Choose the right level switch for the application

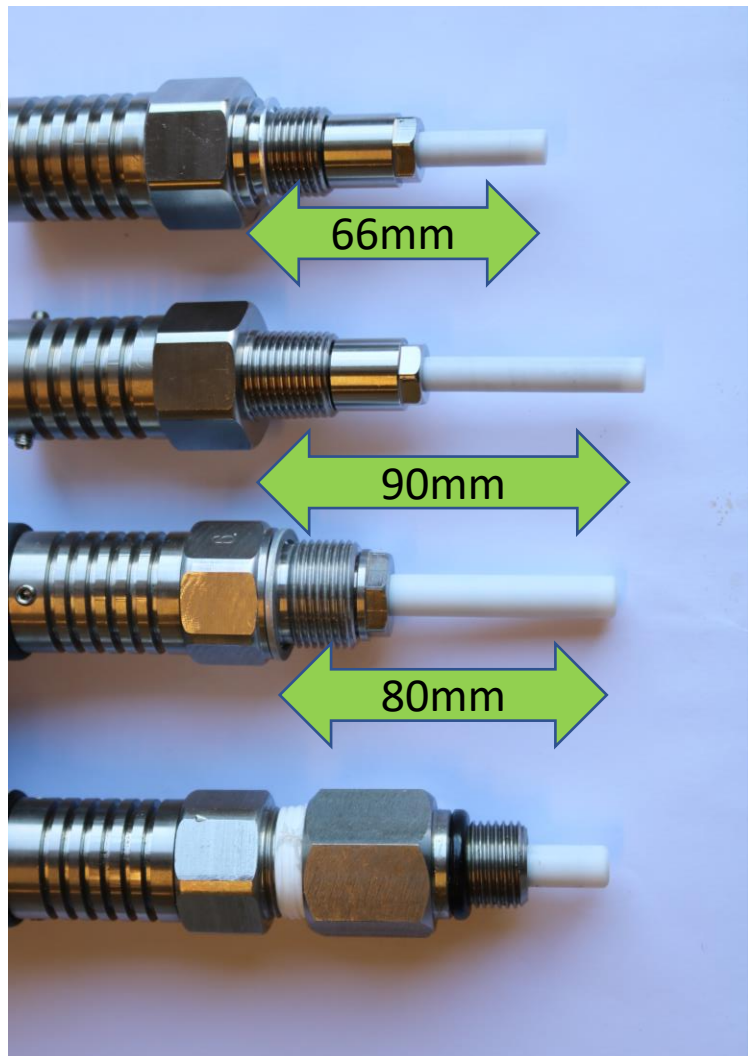
The HBSR ammonia switches are now delivered in $\frac{1}{2}$ " and $\frac{3}{4}$ " versions. We have seen customers using an adapter to fit a $\frac{3}{4}$ " version into a $\frac{1}{2}$ " connection, resulting in malfunction. When a larger part of the sensor tip is sitting in a narrow pipe it will not work properly.

To avoid this construction we have developed two new $\frac{1}{2}$ " versions a normal length and a special short version fitting a Witt oil vessel.
